Seashore Avenue, Peaks Island
(85-F-13)

Sept. 29, 1971

A permit is issued herewith to remove a small platform and add a 7' x 14' roofed over porch subject to the following Building Code requirements:

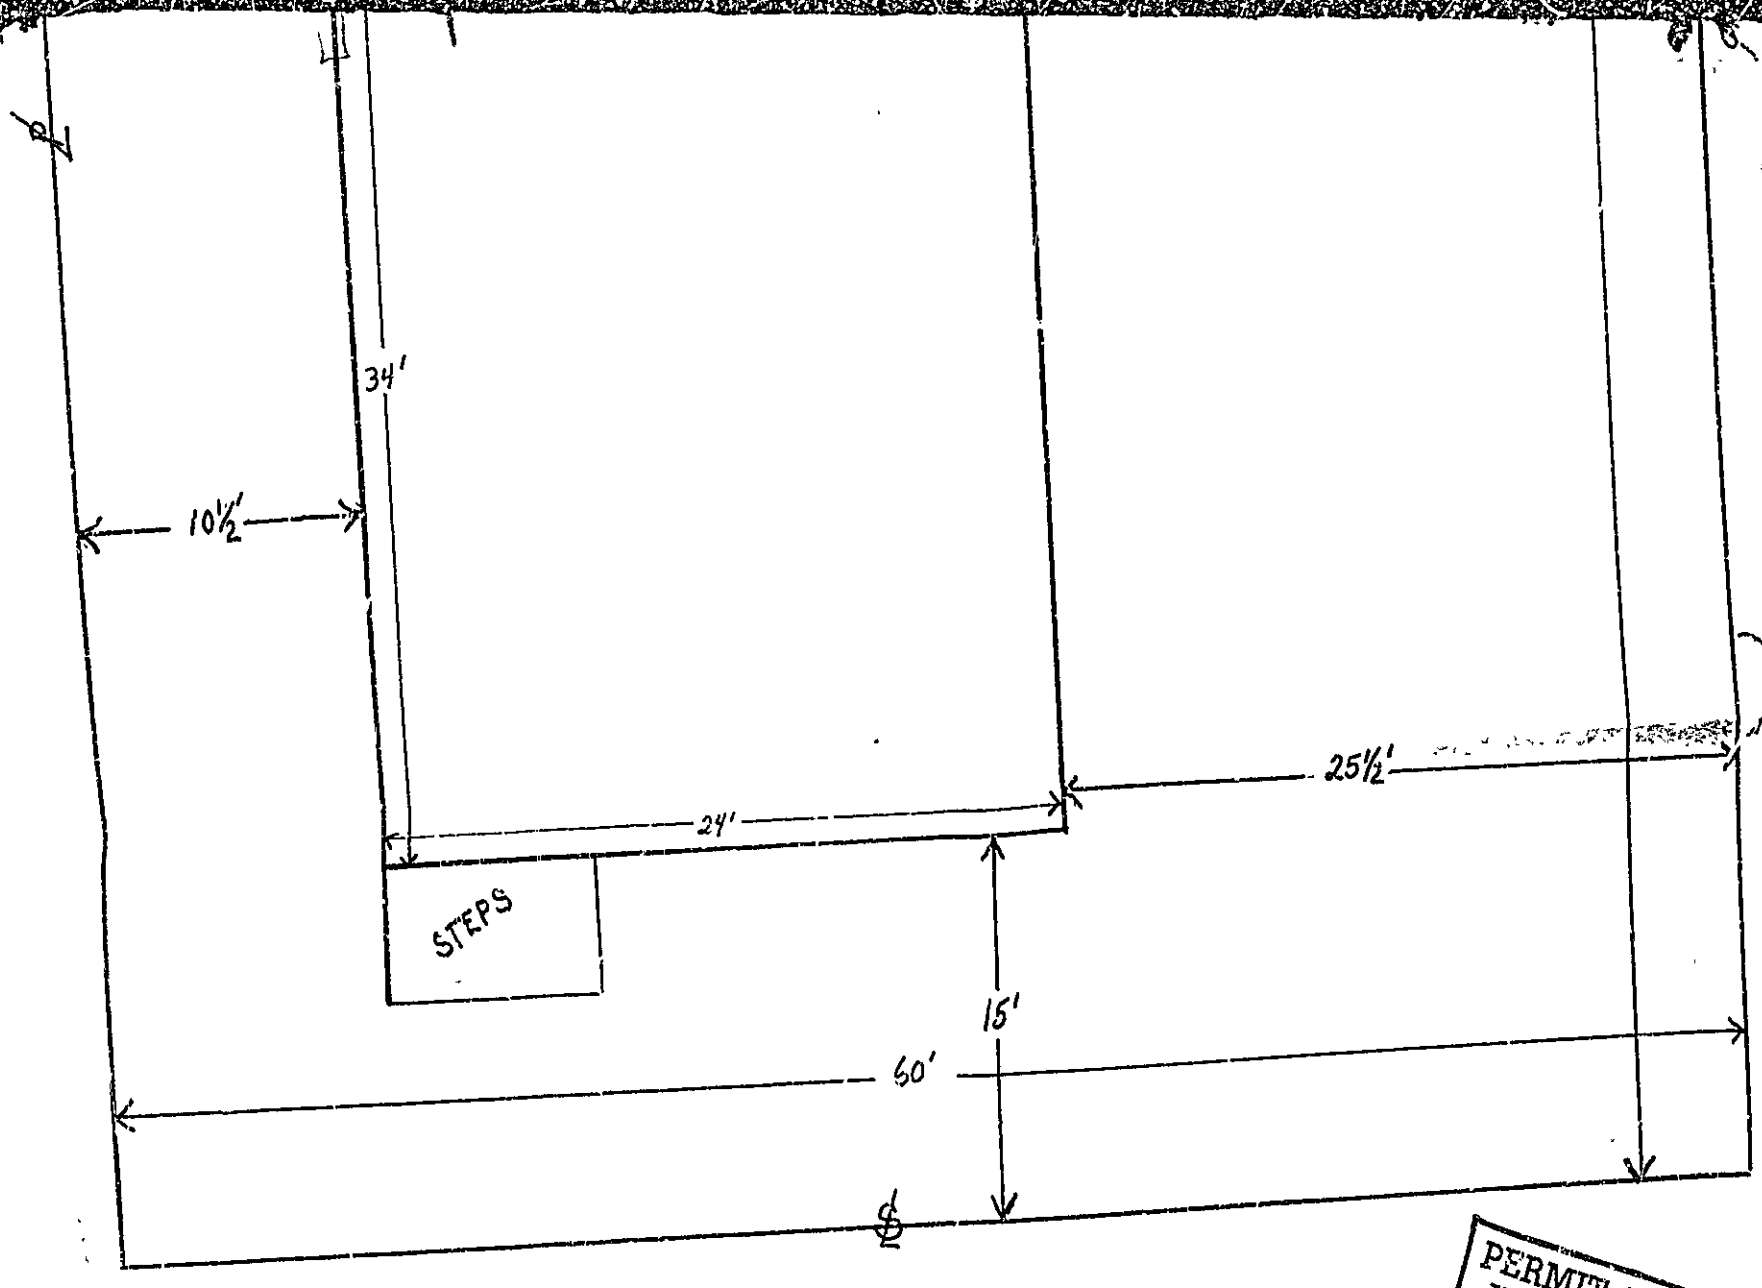
1. The 4x6 sill, all one piece in cross section, with the 6" dimension upright is required to extend around three sides of the platform. The 2x3 floor timbers, 16" o. c.'s notched over nailing strips are required for the platform floor. *Hangers*

2. What will you be using for a plate on the outer edge of the platform which will be used to support the rafters?

Please call Inspector Nelson Cartwright and let him know what you plan to use for a plate in this location and he will note it on the plan which you submitted with the application. *4x6'*
